Date: 12 July 2000  
 To: T10 Technical Committee  
 From: Ralph O. Weber  
 Subject: SAM-2 Byte Count That's Really Buffer Size

**Figure 29 — Model for buffered data transfers**

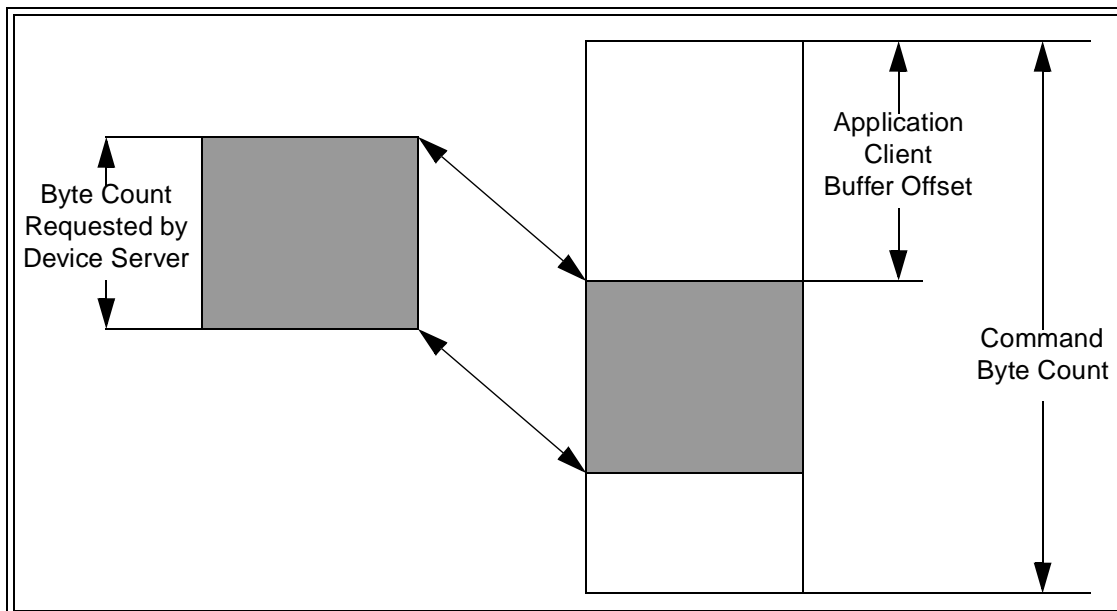
Clearly, this usage of 'command byte count' is the application client data buffer size and exactly the entity that FCP-2 wants to reference.

The working group agreed that SAM-2 should be changed to use the 'command byte count' concept shown in the figure, as opposed to the written definition. This proposal contains a collection of specific SAM-2 changes to meet the working group request.

**Change 4:** In figure 29 (the figure reproduced above) after the second paragraph of 5.3.1 (SAM-2 rev 13 pdf page 70)

**Change 5:** In the descriptions of the *objects* shown in figure 29, after the second paragraph following figure 29 in 5.3.1 (SAM-2 rev 13 pdf page 71)

**Change 7:** In the paragraph that introduces the descriptions of the *objects* shown in figure 29, the second paragraph following figure 29 in 5.3.1 (SAM-2 rev 13 pdf page 71)

Replace 'Command Byte Count' with 'Application Client Buffer Size'

Move the third list entry ('command Byte Count') to the first entry position in the list and replace:

**Application Client Buffer Size:** The total number of bytes in the application client's buffer.

For any specific data transfer protocol service request, the Byte Count Requested by Device Server is less than or equal to the Application Client Buffer Size minus the Application Client Buffer Offset.

The movement of data between the application client and device server is controlled by the following parameters (also depicted in figure 29):
